PLAN COMMISSION REPORT

Proposal: Cooperative Boundary Agreement Review

Description: Review a building, site, and operation plan for the construction and utilization of a ±53,000 square-foot commercial building located at 3030 CTH K to ensure compliance with the Cooperative Boundary Agreement between the Village of Raymond and the Village of Caledonia.

TO: Village of Raymond Plan Commission
CC: Barbara Hill, Jeff Muenkel, Kari Morgan, Mark Molinero
FROM: Ben Kohout, AICP, Planning Consultant
RPT DATE: February 18, 2025
MTG DATE: February 24, 2025
APRVL DATE: February 24, 2025
RE: Milwaukee Powersports, Inc. –Conditional Use Permit & Site Plan Plan Operations
(SPPO) Review, Soils Disturbance Request (Greater than one acre)

**LANDSCAPE PLAN
 MILWAUKEE POWERSPORTS
 RAYMOND, WISCONSIN**

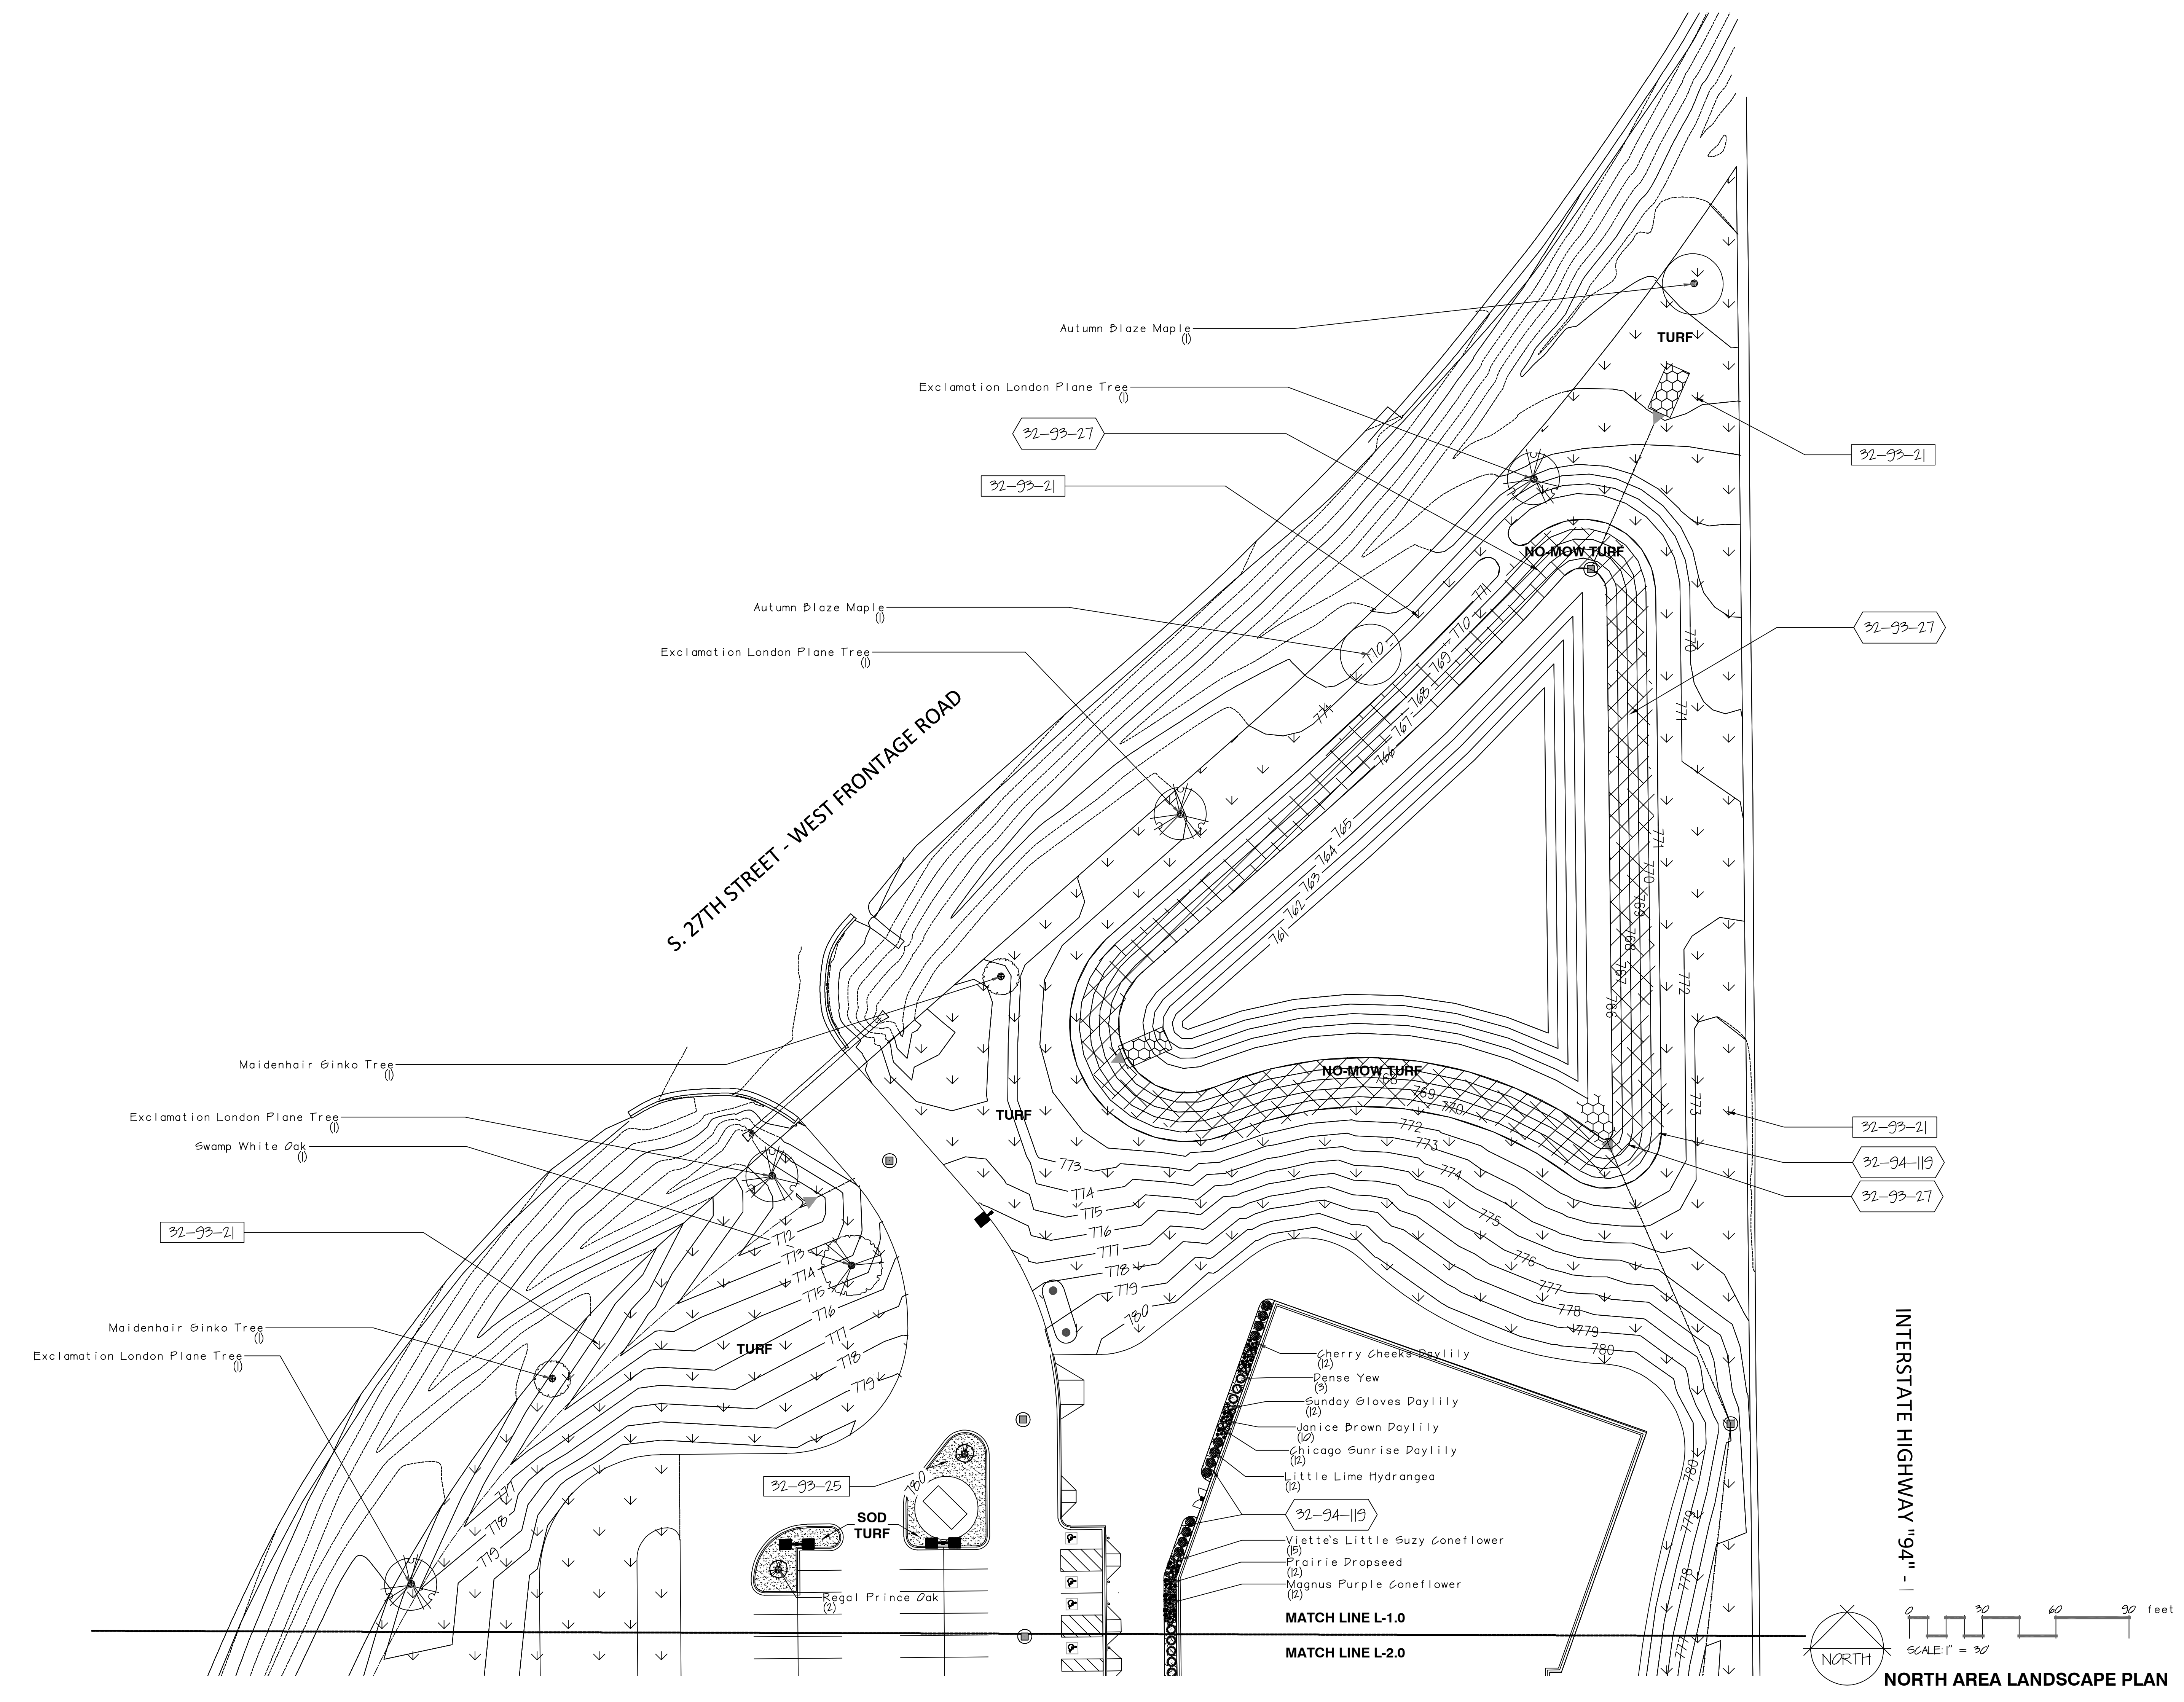
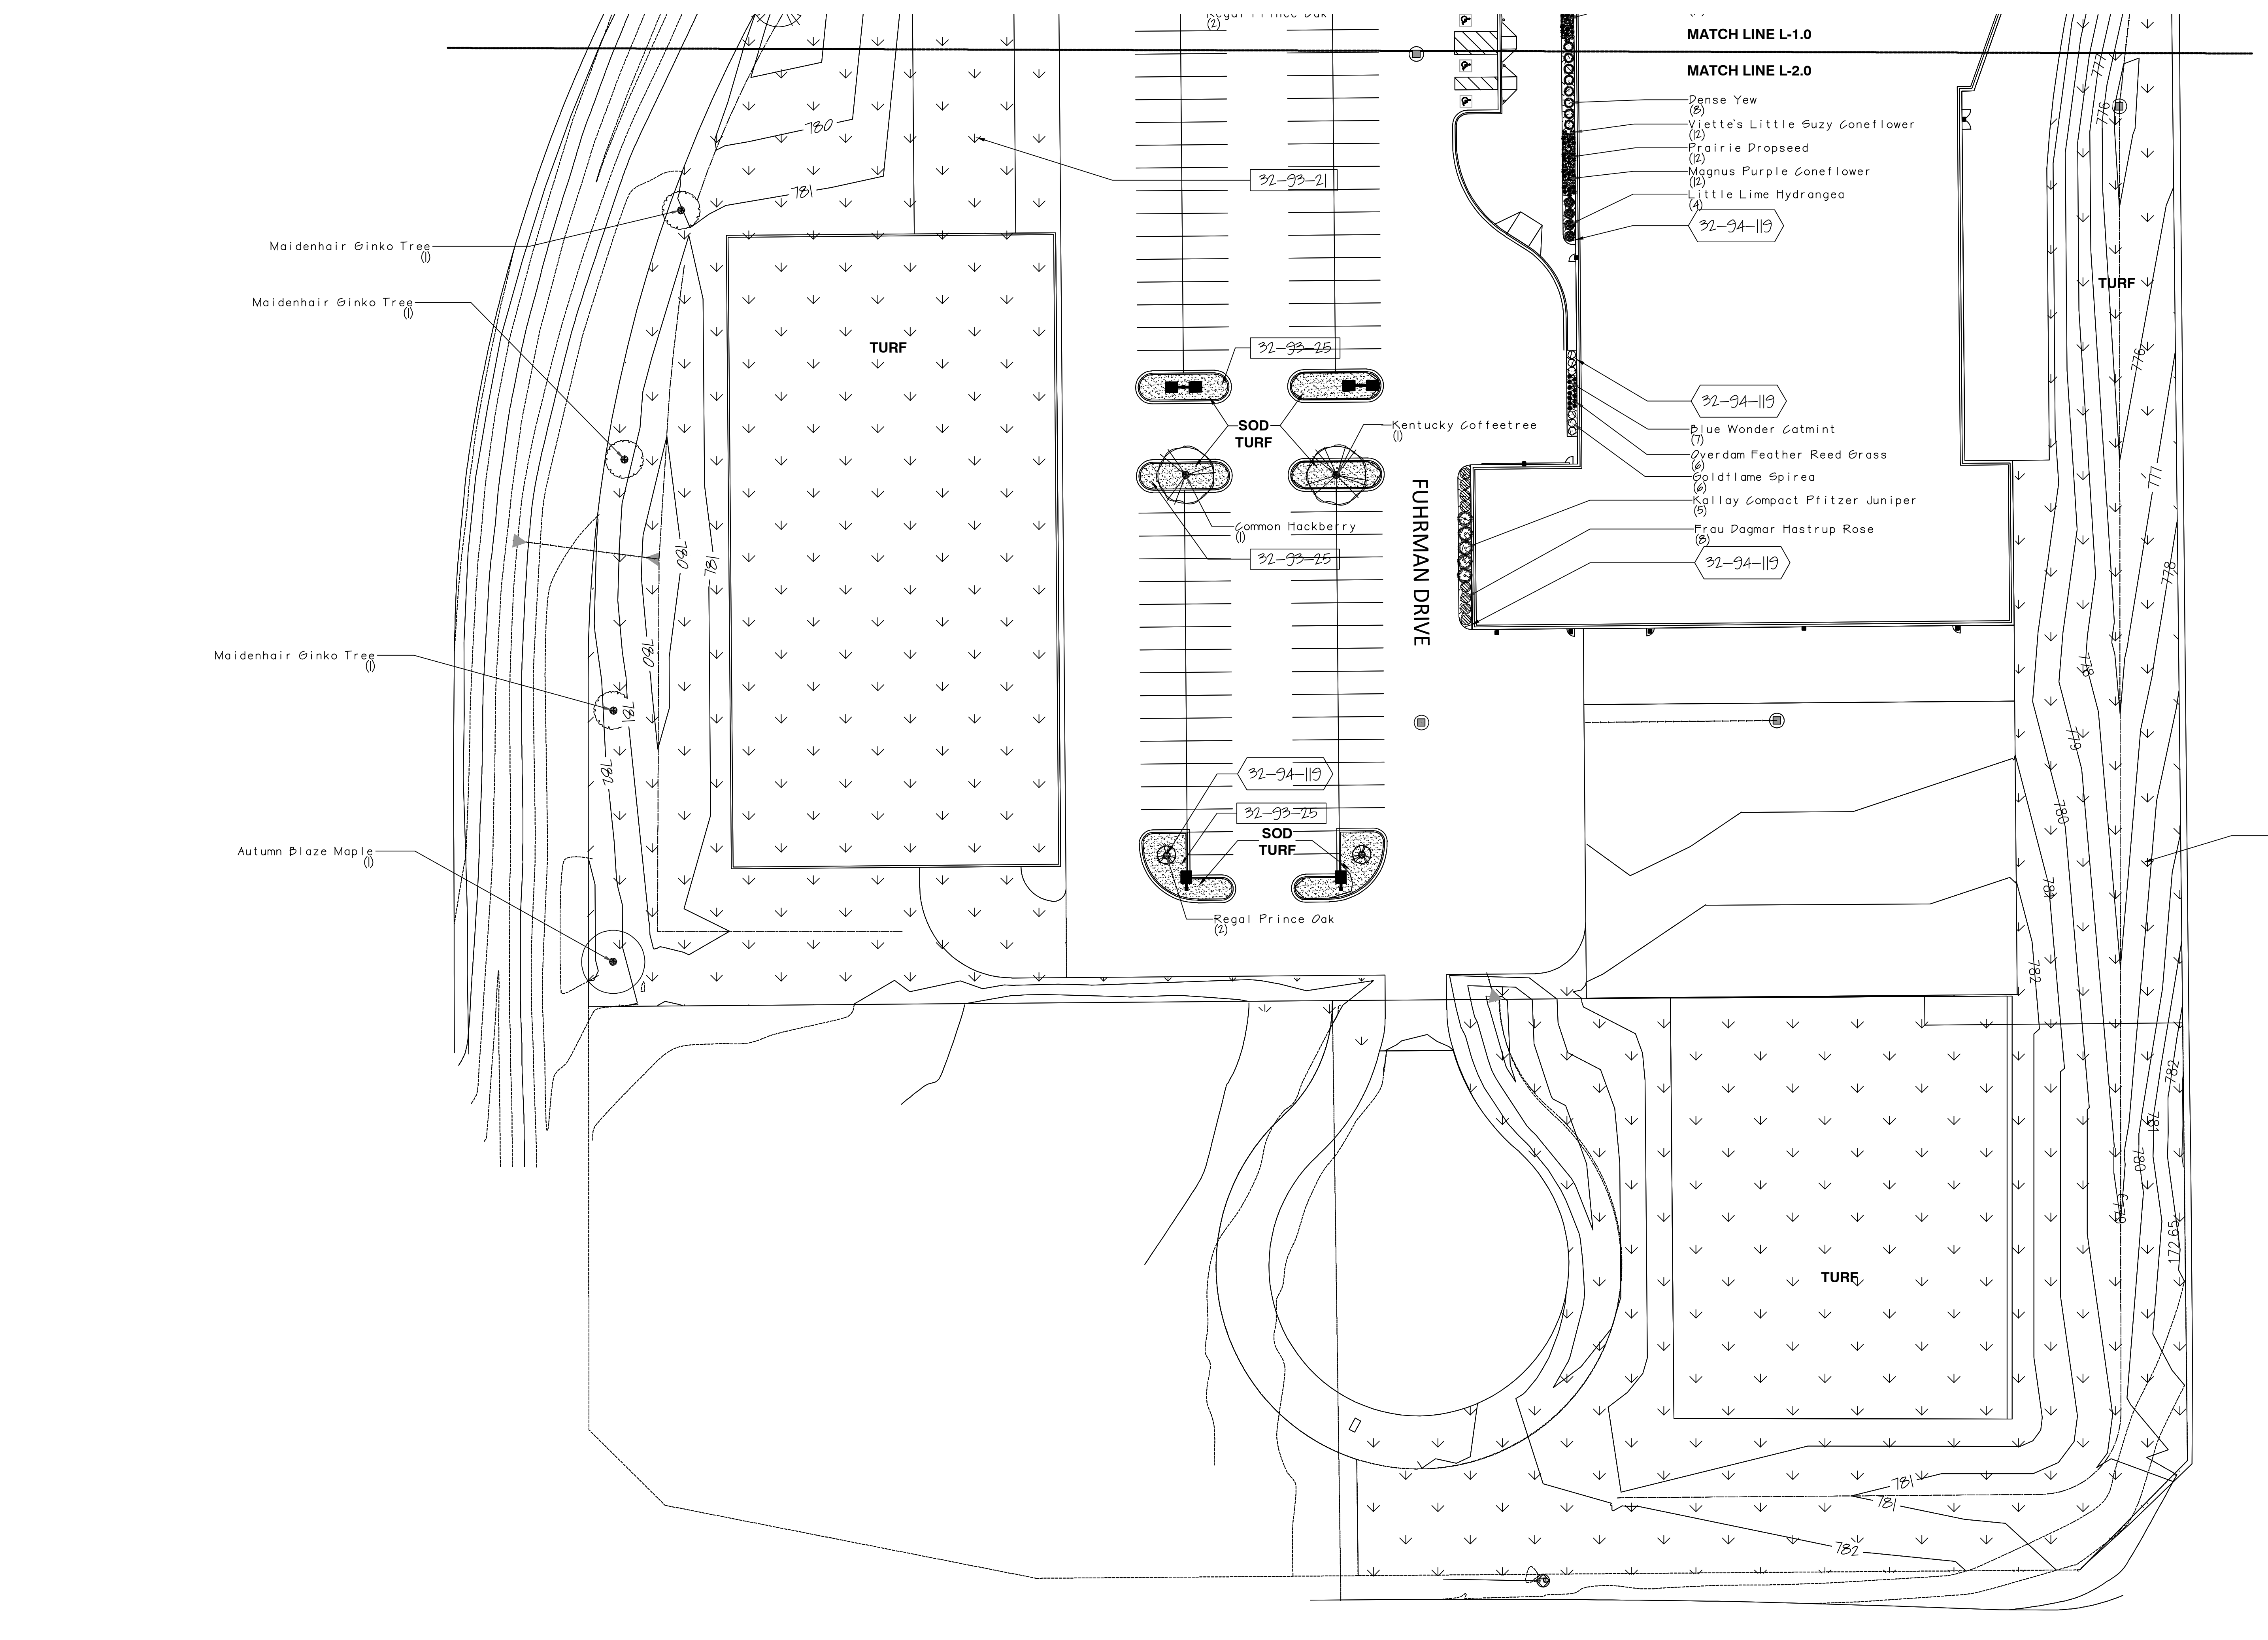
The agreement requires screening of service areas, storage, and mechanicals with fences, evergreen plantings, or opaque materials at least 7 feet high. Exhibit K states that landscaping along roadways should include having deciduous trees located a minimum of 50 feet apart. In addition, there should be a secondary landscape layer to screen parking areas. The development plan incorporates landscape screening with staggered plantings of white pine and Norway spruce to shield outdoor storage. However, based on the linear frontage along the frontage road, the development should include 24 trees where only 12 are being proposed. A minimum of six trees should be planted along CTH G. Furthermore, design standards require a secondary landscape layer behind the trees screening parking areas. No secondary layer of landscaping is being proposed on the western side of the parking lot. A future storage building in the area does not exempt the applicant from complying with the landscape requirements.

Staff believes the proposal mostly complies with the Cooperative Boundary Agreement by adhering to zoning requirements and architectural standards. However, the proposed landscape plan does not meet the minimum requirements in Exhibit K nor does it address how building mechanicals will be screened from the roadways. If the Plan Commission agrees that the proposed building, site, and operation plan complies with the design standards outlined in Exhibit K, the Plan Commission can recommend approval which staff has drafted a suggested motion for consideration.

The applicant is proposing a staggered planting of white pine and Norway spruce evergreens to be planted on the east and southern sides of the proposed outside vehicle display area, on the south side of the main building.

- e. **Landscaping:** The applicant has provided a landscape plan including landscaped islands in the parking lot area and grass and tree plantings around the vehicle display area. The Village code is silent as to a prescribed landscaping planting schedule minimums, and leaves it up to the Village to decide if what is proposed is appropriate as to the nature of the property and its surroundings.

Staff generally finds the plans acceptable in terms of detailing the limits of grass areas, and noting the sizes and species of plantings are called out, which meet minimum standards specified in the ordinance.

The applicant should provide plans for ongoing maintenance of landscaping, including mowing and weed management on landscaped berms. This can be a short statement on the landscape plan describing maintenance procedures should a planting be damaged or die.

- b. Landscaping plan shall be in accordance with plans presented to the Commission on February 24, 2025, and updated to include details in a statement that there are "plans for ongoing maintenance of landscaping, including mowing and weed management on landscaped berms" and specifying "should a planting be damaged or die, it shall be replaced within the next available growing season".
